Drawing Change Notice

CHANGE DOCUMENT NO.
24590-PTF-VDCN-MS-10-00008

JOB NO.	TITLE FOR CHANGE NOTICE
24590	UFP-VSL-00062B Redesign

JUSTIFICATION FOR CHANGE	CAUSE CODE
Based on the re-analysis of UFP-VSL-00062B, per calculation 24590-PTF-MVC-UFP-00023, for revised seismic conditions and design evolution, required a redesign of the vessel.	01 and 23

SECTION D-D
SCALE: 1/16

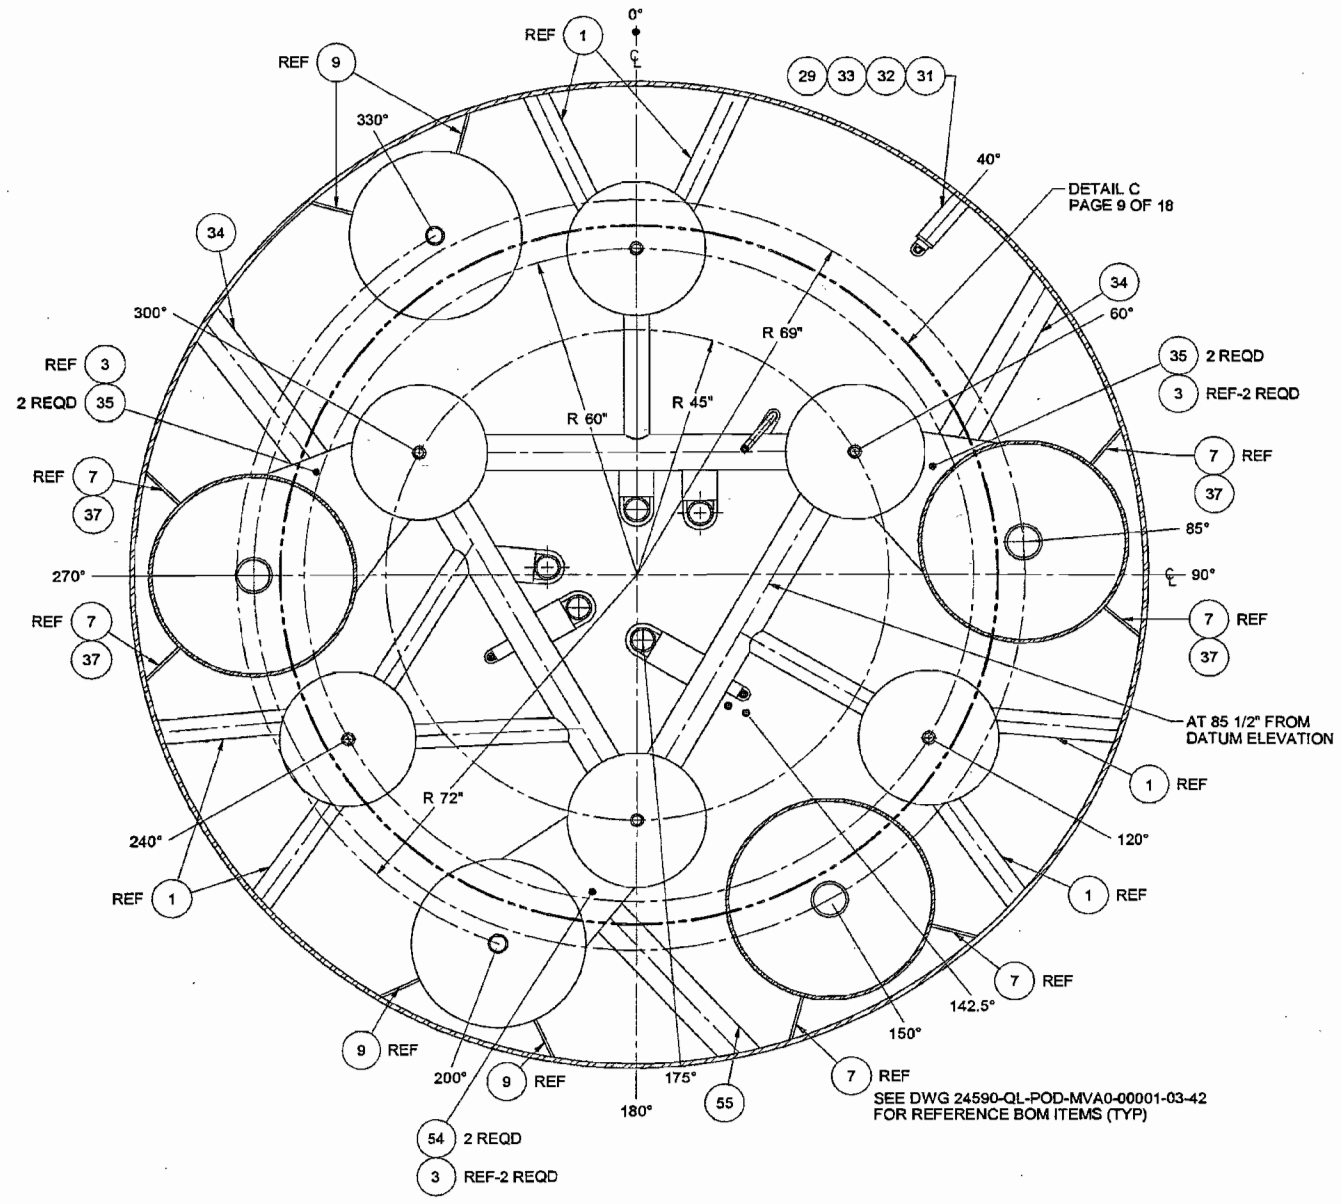
j.) Add SECTION D-D shown on Attachment 1, page 8 of this VDCN.

SECTION E-E
SCALE: 1/16

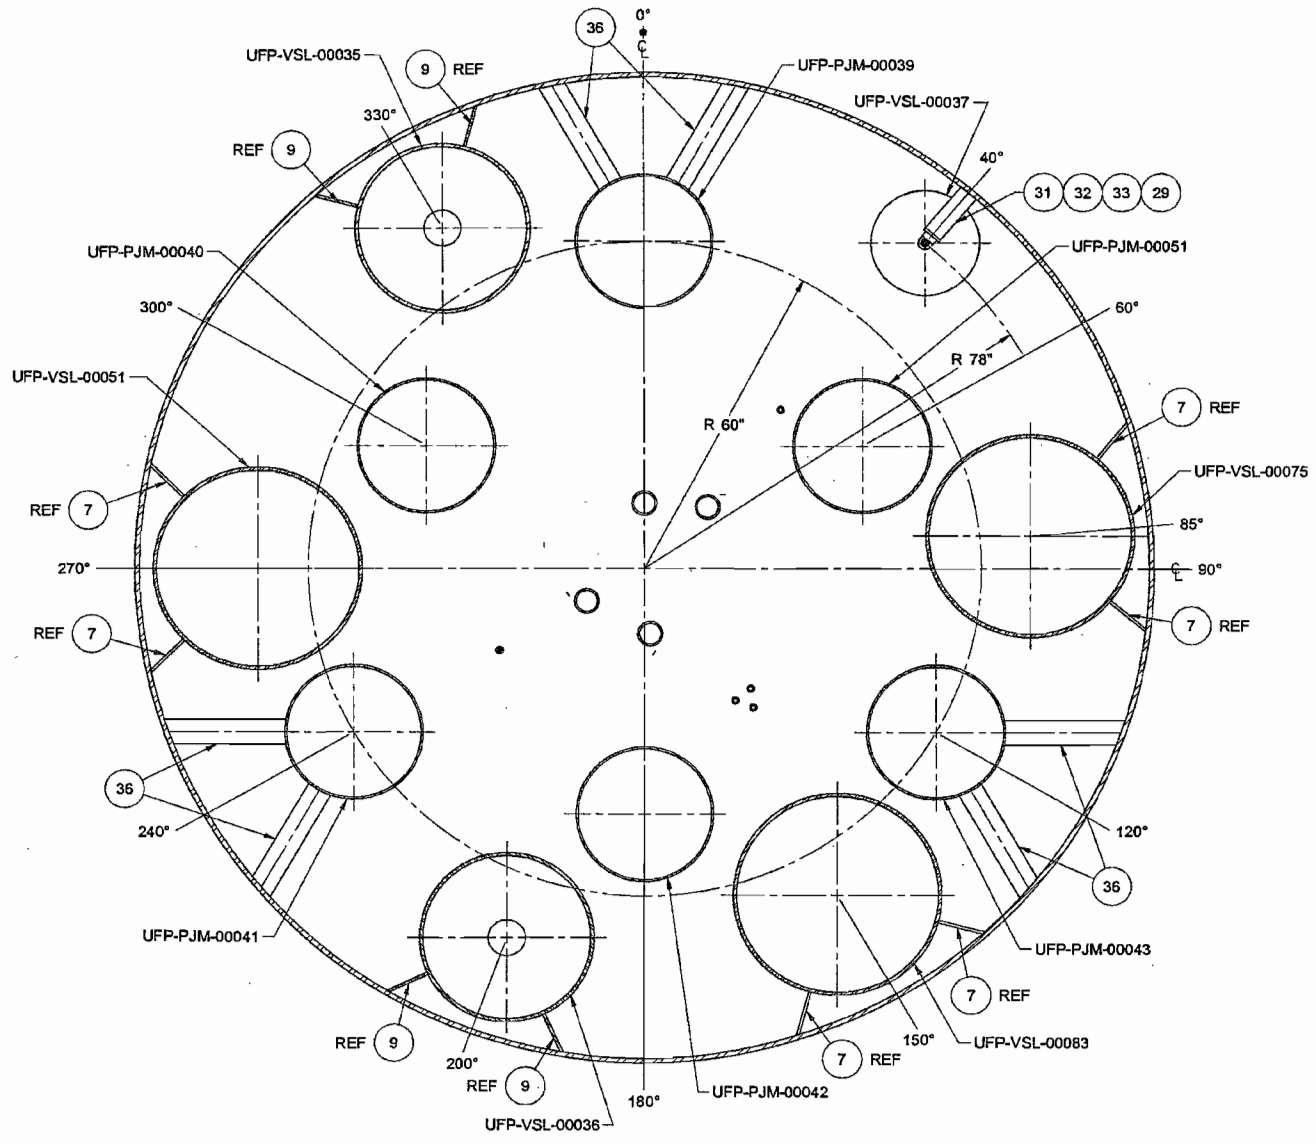
k.) Add SECTION E-E shown on Attachment 1, page 8 of this VDCN.

DETAIL C
SCALE: 1/8

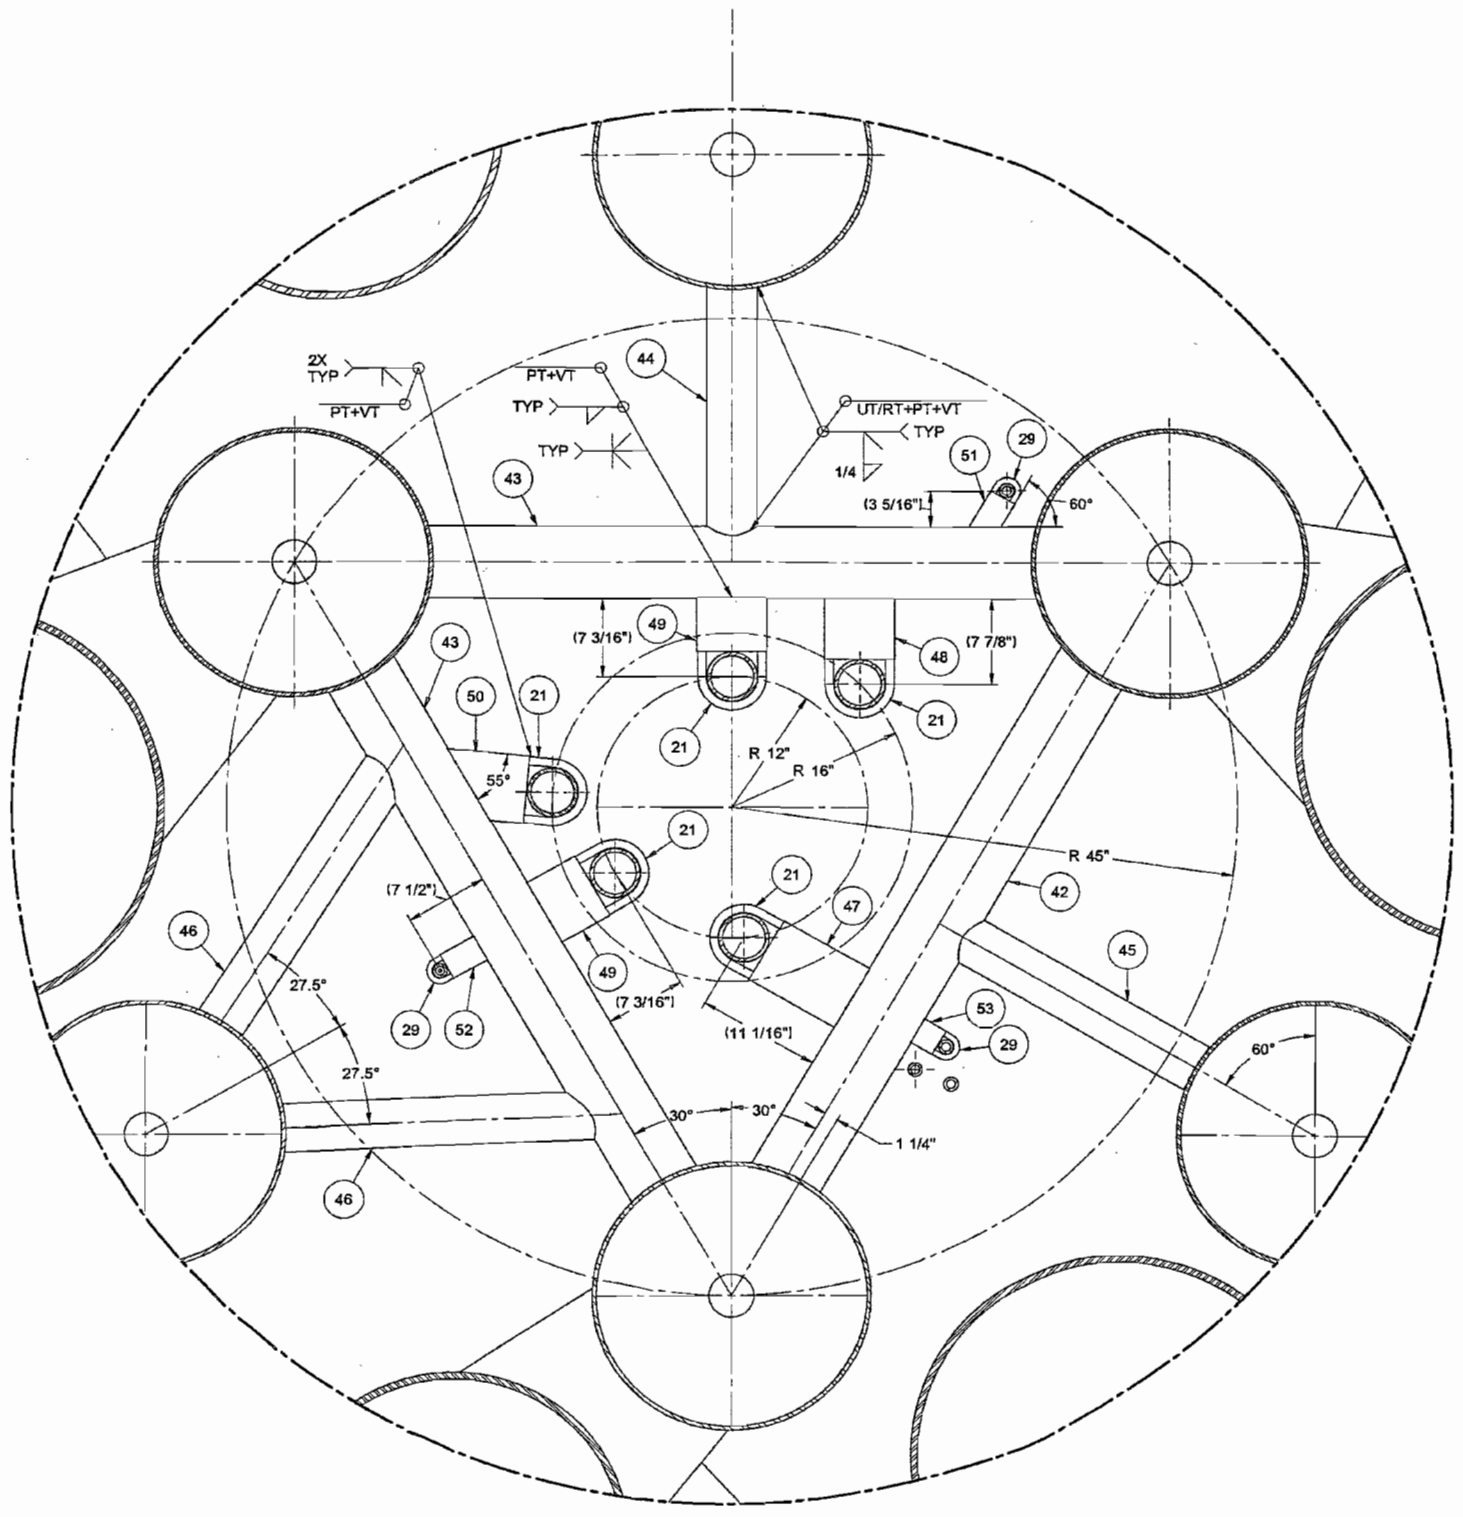
l.) Add Detail C shown on Attachment 1, page 9 of this VDCN.

2" SCH 80 NOZZLE W/ INT. PROJECTION
SCALE: 3/4" = 1"
N07 N09 N10 N11 N14 2 3

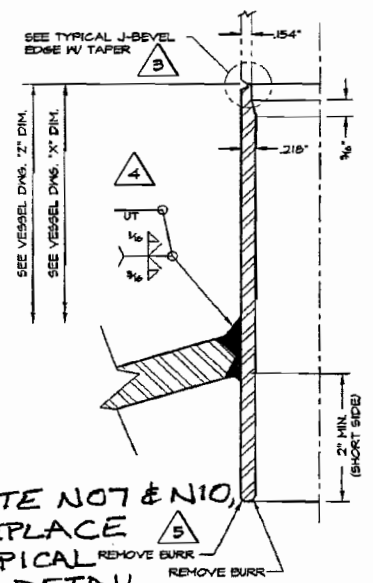
b.) 2" SCH 80 NOZZLE W / INT PROJECTION: Delete N07 and N10 and replace with Typical 160 SCH Detail.

DELETE N07 & N10, AND REPLACE WITH TYPICAL SCH 160 DETAIL BY RPP-WTP 5

2 / - TYP. LOWER SUPPORT FOR DIP TUBES
NO SCALE

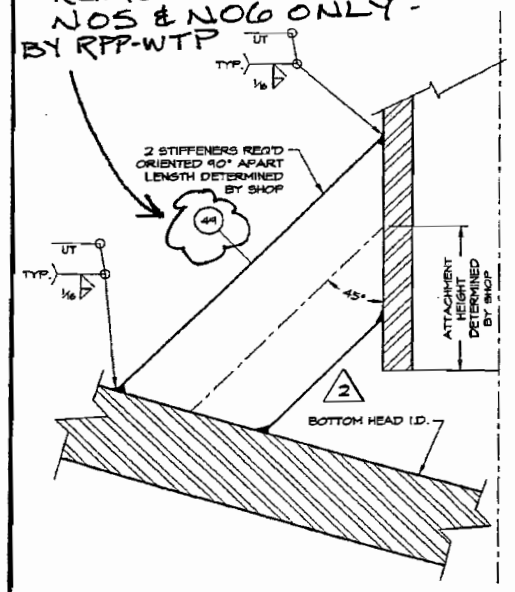
a.) Typ Lower Support For Dip Tubes: Remove support item 49 for N05 and N06 only.
NOTE: This support detail is covered on Vendor drawing 24590-QL-POD-MVA0-00001-03-32 as reflected in item 5 of this VDCN.

REMOVE ITEM 49 FOR N05 & N06 ONLY - BY RPP-WTP

SECTION F-F
SCALE: 1/16

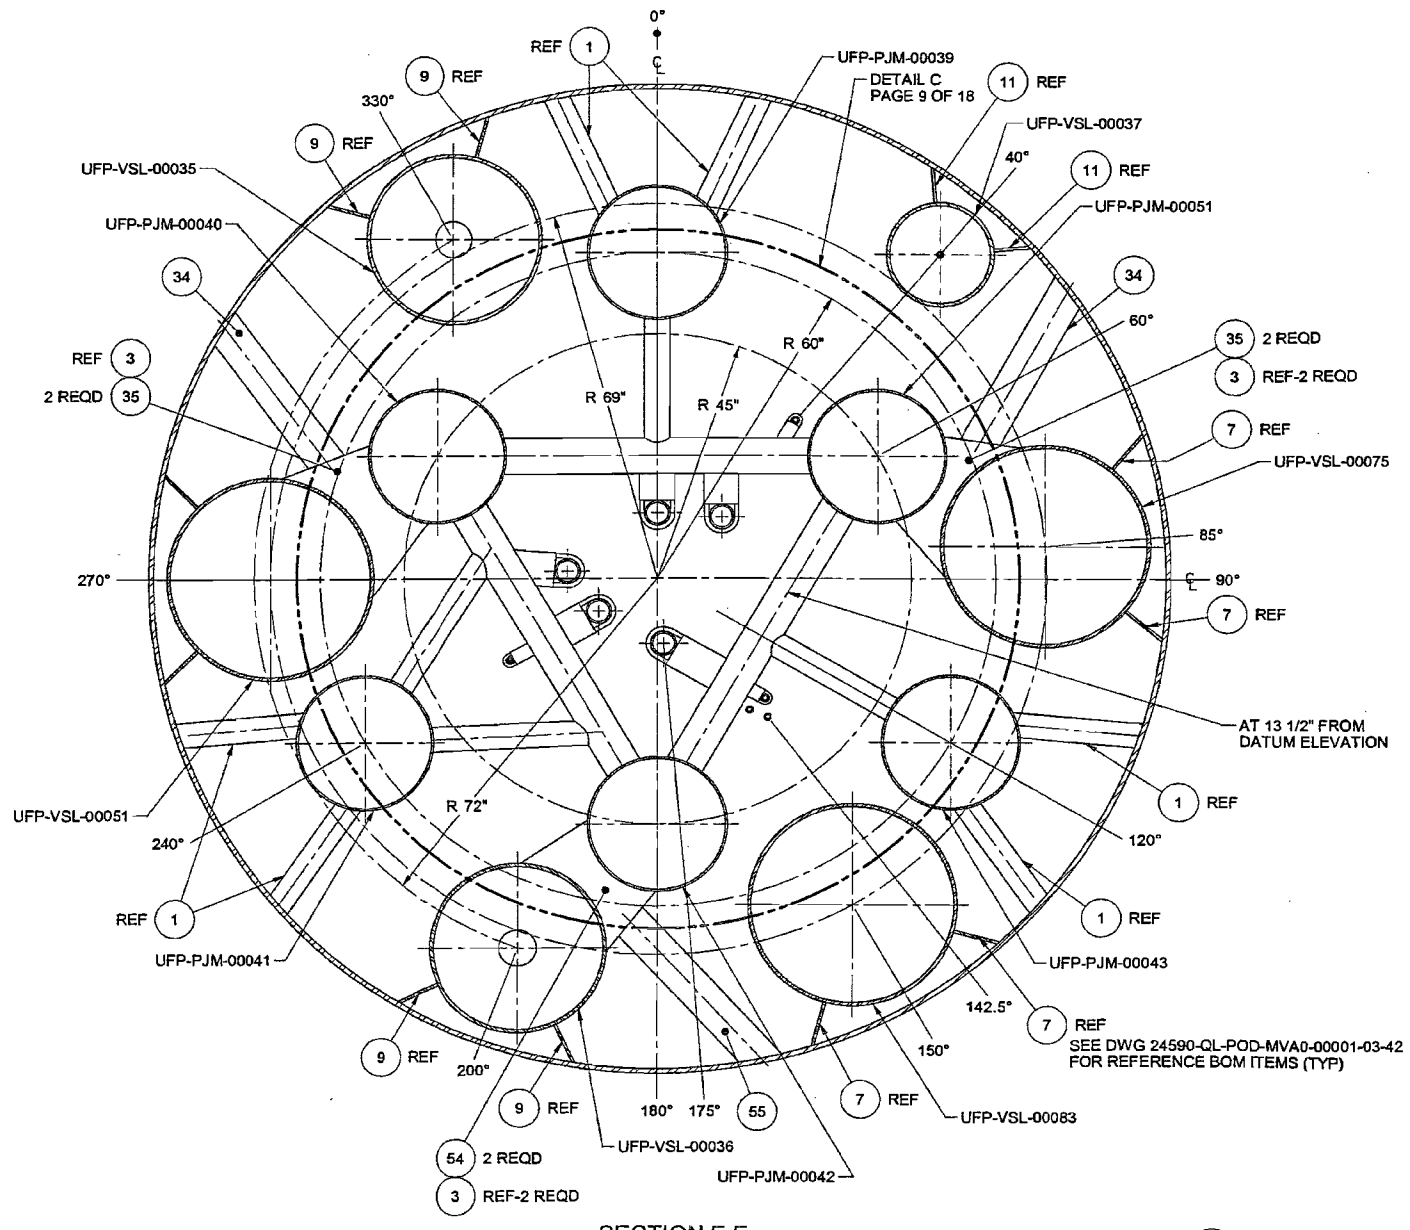
m.) Add SECTION F-F shown on Attachment 1, page 12 of this VDCN.

SECTION G-G
SCALE: 1/16

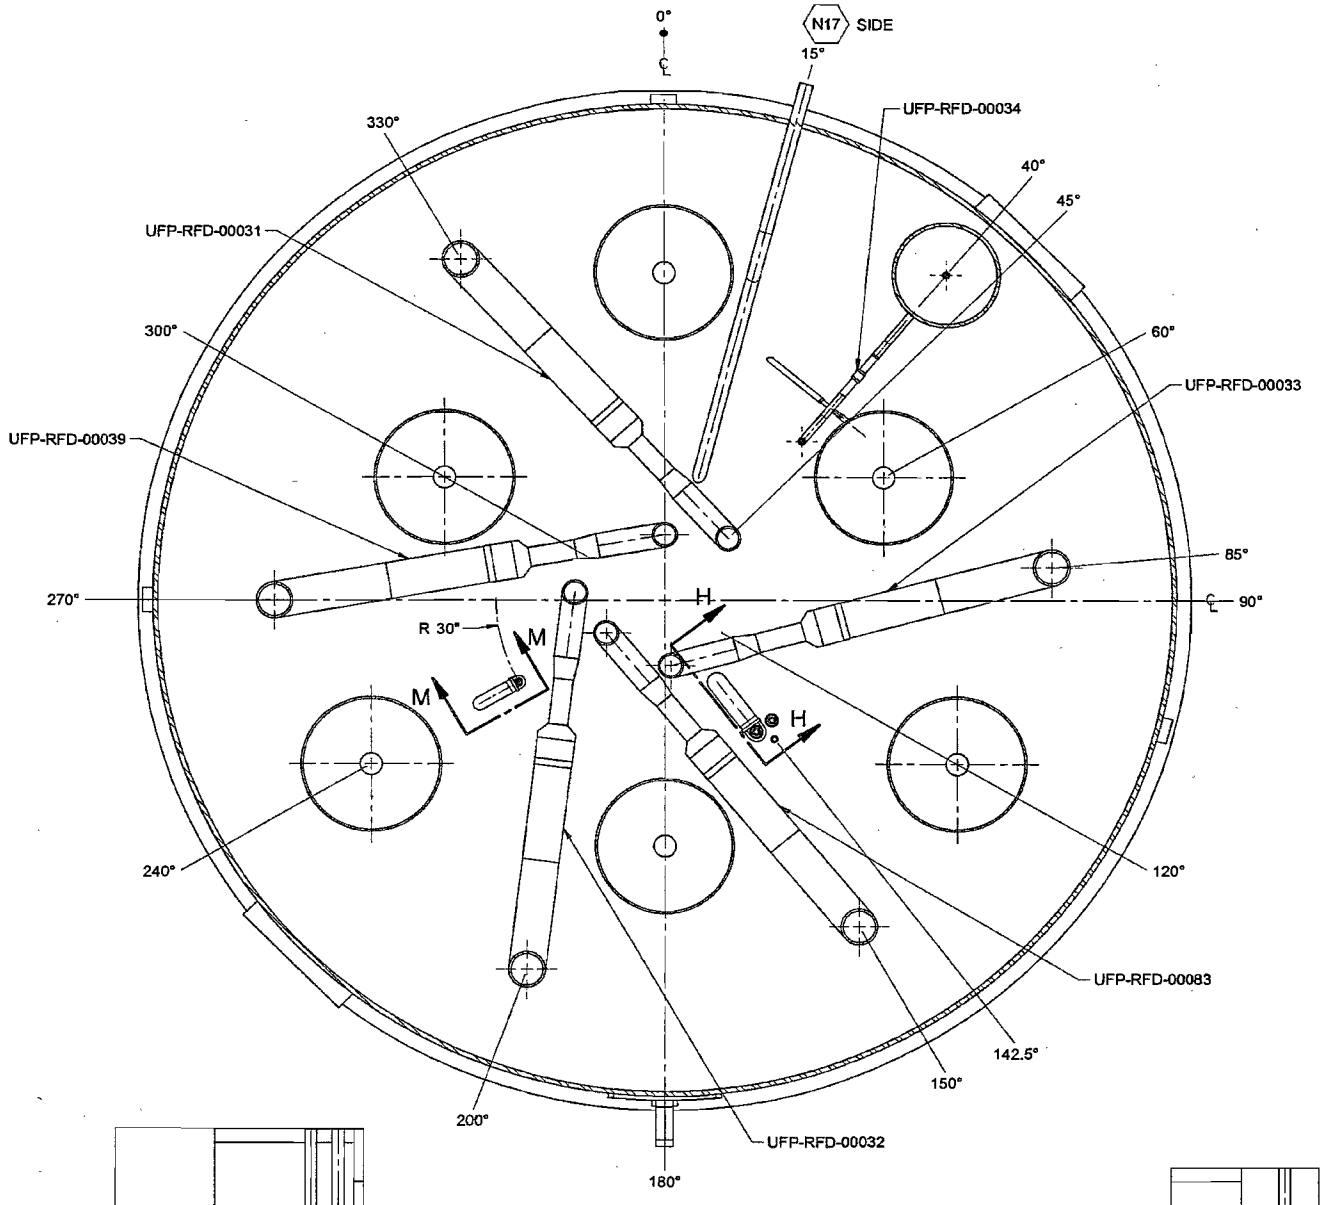
n.) Add SECTION G-G shown on Attachment 1, page 12 of this VDCN.

SECTION H-H
SCALE: 1/10

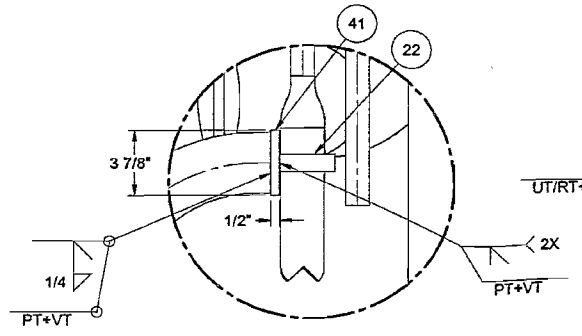
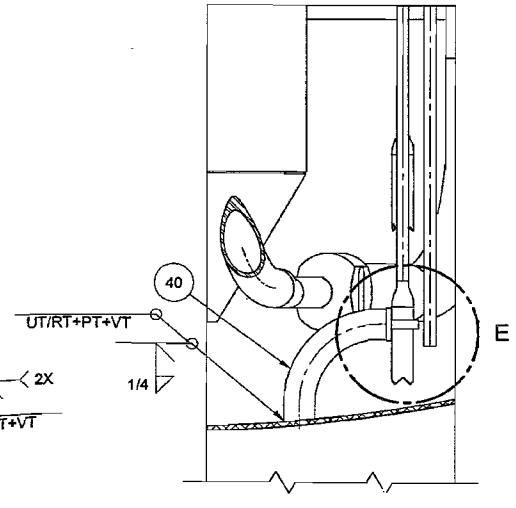
a.) Instrument Assy Detail: Remove support item 49 and replace with SECTION H-H and DETAIL-E shown on Attachment 1, page 12 of this VDCN.

SECTION M-M
SCALE: 1/10

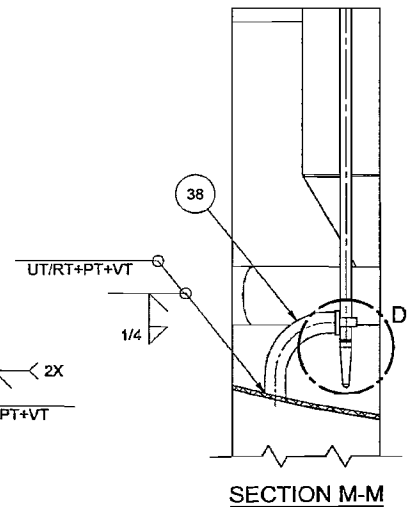
b.) Thermowell Assembly: Remove support item 49 and replace with SECTION M-M and DETAIL-D shown on Attachment 1, page 12 of this VDCN.
